COUNCIL BILL NO. 2003 - 378

Preliminary Plat - Catalpa Station

PRELIMINARY PLAT - CATALPA STATION

EXHIBIT A

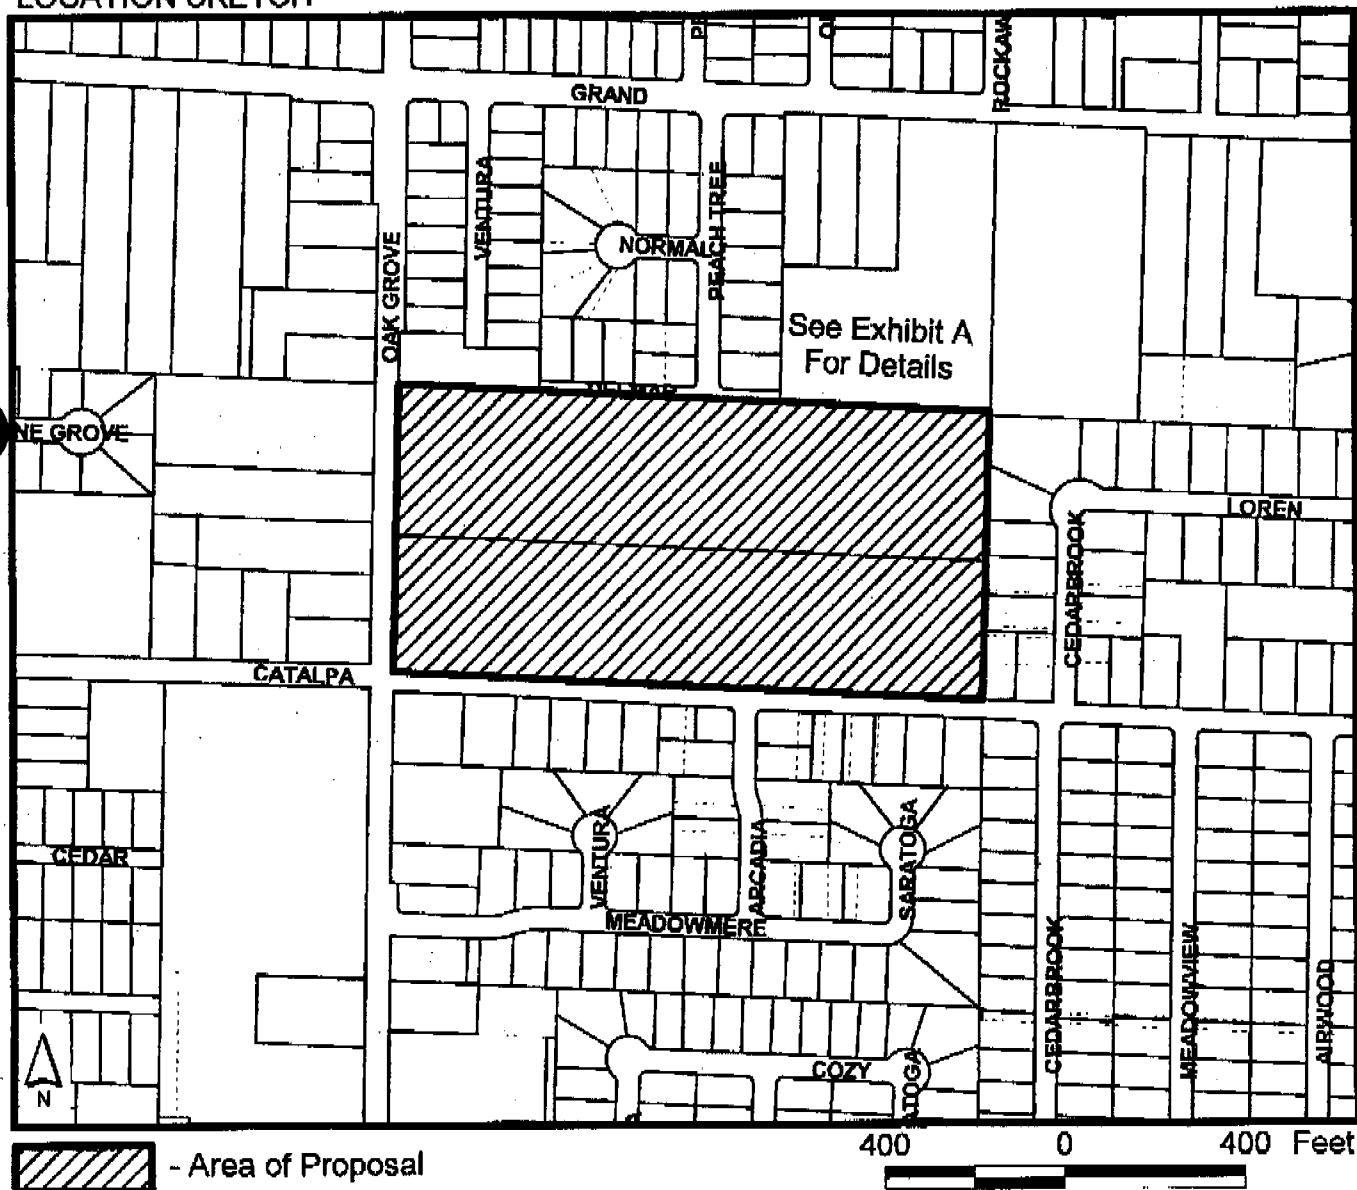
1. A ten foot wide utility easement is required on the street side of all lots.
2. In the northwest detention basin, care should be taken in design of the outlet structure to avoid an existing 14-inch welded-steel, high-pressure gas main. Any relocation work will be at the developer's expense.

3. A 4-inch, high-pressure plastic gas main runs along the southern property line. Please preserve this utility and any related easements.

1. Please provide 10 foot wide utility easements along all rear lot lines.

1. The original preliminary plat had Saratoga Avenue intersecting with Catalpa Street and Arcadia Avenue was a cul-de-sac. In the new preliminary plat (Exhibit A) Saratoga Avenue is a cul-de-sac which extends further north than in the original preliminary plat, and Arcadia Avenue intersects with Catalpa Street directly across from the existing intersection with Arcadia to the south of Catalpa. The new preliminary plat shows Loren Street with a jog at Arcadia where the street was straight on the previous preliminary plat. The new preliminary plat also has six lots on Delmar opposite the existing homes while the original preliminary plat showed only four lots. The new preliminary plat has 61 lots, while the original preliminary plat had 68 lots. Although the new preliminary plat has the same number of lots along the eastern plat boundary as the original preliminary plat, they are wider lots. Staff feels it is a positive change for Arcadia Avenue to align with the street segment on the south side of Catalpa rather than further east at Saratoga as it was shown on the preliminary plat. Relocating the street means the existing homes on the south side of Catalpa will not have headlights shining in their windows. It is also a positive change that the total number of lots has been reduced. This results in slightly less traffic. Saratoga will extend further north which means that the northernmost existing lot on the west side of Cedarbrook will have a house behind it rather than the detention basin as shown on the original preliminary plat.

2. Traffic Engineering does not support the cul-de-sac at the western end of Delmar Street (see Attachment B for the full comments). The decision to not connect Delmar with Ventura or Oak Grove Avenues was made with the submission of the first preliminary of Catalpa Station. Part of the subdivision drains to the northwest corner where Delmar Street would be located. The property is extremely flat and the developer's engineer calculated that if Delmar (and the associated fill) was extended through where the detention had to be located, that the detention would not be large enough and it would mean losing a number of buildable lots which the developer could not afford to do and still pay for the public improvements. At that time, Traffic Engineering did not express their concern about the lack of interconnectivity between these two subdivisions. The preliminary plat of Catalpa Station was approved. When the developer of Elmwood Place Phase 2 submitted that subdivision for review by the Administrative Review Committee, Traffic Engineering did not express their concern about the lack on interconnectivity between the two subdivisions. The developer proceeded with the preliminary plat for Elmwood Place Phase 2. Now that changes in the preliminary plat of Catalpa Station are causing that preliminary plat to be re-approved, it happens that both preliminary plats are scheduled to appear on the same Planning and Zoning Commission agenda and Traffic Engineering is concerned about the lack of

1. Traffic Engineering does not support the cul-de-sac at the end of Delmar Street toward the western side of the development. Delmar Street needs to be constructed Public Works residential street standards to the western property line and a portion of Delmar Street needs to be constructed to connect to Ventura Ave. The developer needs to work with the developers of Elmwood Place Phase 2 in the construction of Delmar Street. This will allow for connectivity of Ventura Avenue and Delmar Street and the neighborhoods.

1. The developer must meet full detention and extended detention requirements for water quality.
2. The entire site must drain to the detention areas.
3. The developer must provide a sediment and erosion control plan.
4. The exact sinkhole and drainage easement limits will be defined on the final plat based on storm water and geologic studies.
5. The altered west detention area appears to be large enough based on a rule of thumb estimate. Review of the final plans will determine if it needs to be changed.
6. The east detention basin must discharge to a public right-of-way, drainage easement or certified natural drainage channel.

- a. Public sanitary sewers shall be extended to all building sites.
 - b. Sidewalks, in accordance with the *Subdivision Regulations*, shall be constructed along the East side of Oak Grove, the North side of Catalpa Street and on one side of all internal streets.

- c. The east detention basin shall discharge to a public right-of-way, drainage easement or certified natural drainage channel.
2. All required street rights-of-way, drainage and utility easements and limitations of access shall be dedicated on the final plat.

- a. No driveways shall be permitted to either Catalpa Street or Oak Grove Avenue from any abutting lot.
 - b. Additional right-of-way shall be dedicated for both Catalpa Street and Oak Grove Avenue to total thirty-five (35) feet from the centerline of each street. A fifty (50) foot by fifty (50) foot right-of-way triangle shall be dedicated at the intersection of the new rights-of-way lines for Catalpa and Oak Grove.

- c. A ten (10) foot wide utility easement shall be dedicated along the street side of all lots. The 4-inch, high-pressure plastic gas main runs along the southern property line and any related easements shall be preserved.

- d. The exact sinkhole and drainage easement limits shall be defined on the final plat based on storm water and geologic studies and shall be labeled as sinkhole limits and drainage easement. No buildings, fences or fill shall be permitted within these areas.
